**From:** Mark Chester <[REDACTED]>  
**Sent:** 06 April 2021 12:45  
**To:** [REDACTED] Gavin Boyes - Arboricultural Team  
**Subject:** New TPO for Redditch Road, Alvechurch  
**Attachments:** Comments on a new Tree Preservation Order on land by 28 Redditch Road Alvechurch.pdf

**Comments on a new Tree Preservation Order on land by  
28 Redditch Road, Alvechurch  
For Mr. Matthew Smith**

TITLE: Site Plan

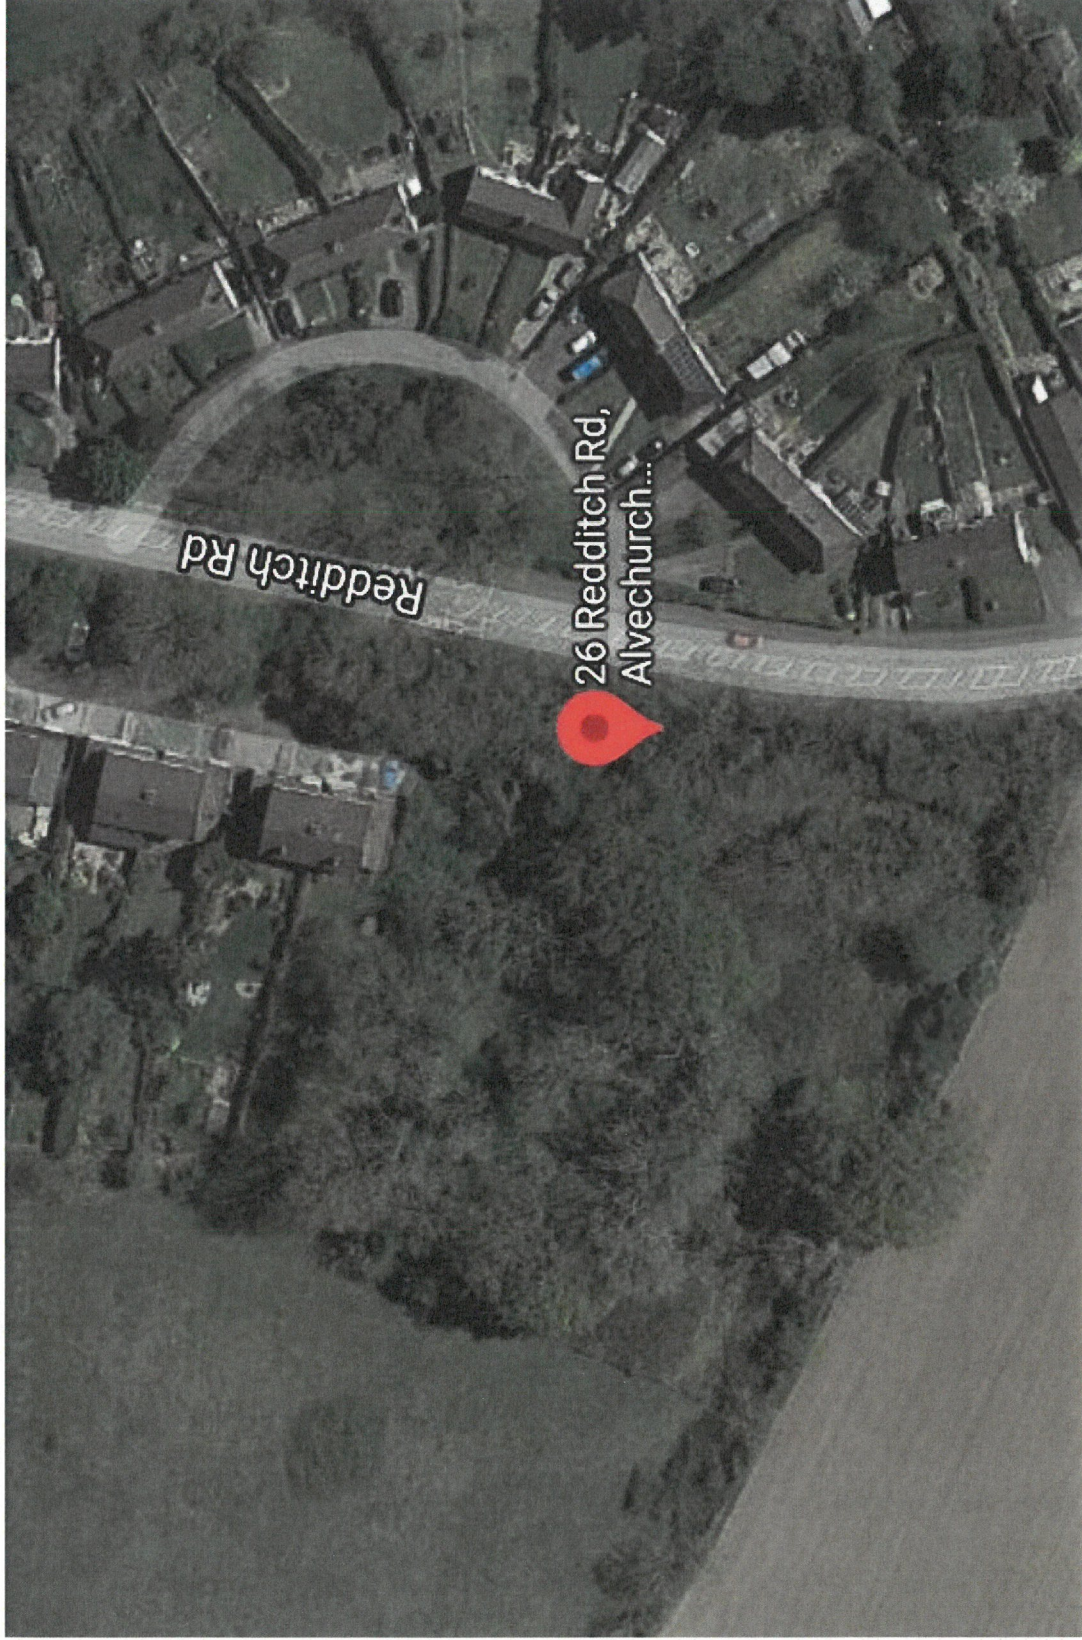
1. Seven trees have been identified for inclusion, with a grid reference used for each, and a position shown on a site plan. In the absence of the grid reference on the site plan, it is unclear which the seven are. The group of five are part of a group of eight trees. In addition, the one to the rear of 28 Redditch Road, to the west, is one of three trees.

2. It is unclear why these seven trees were included in the Order, in preference to others.
3. There is no amenity assessment of the trees, to demonstrate how their inclusion has been merited. Some of the trees have extensive dead wood, and with the site being privately owned, it is unclear how an officer would have obtained access to the inner part of the site to assess any of the seven trees. The TEMPO assessment is applied to tree T7, by 28 Redditch Road, and also to trees T2-6, which are within the site. The assessment indicates that the trees may not merit inclusion in the Order. Details are below.
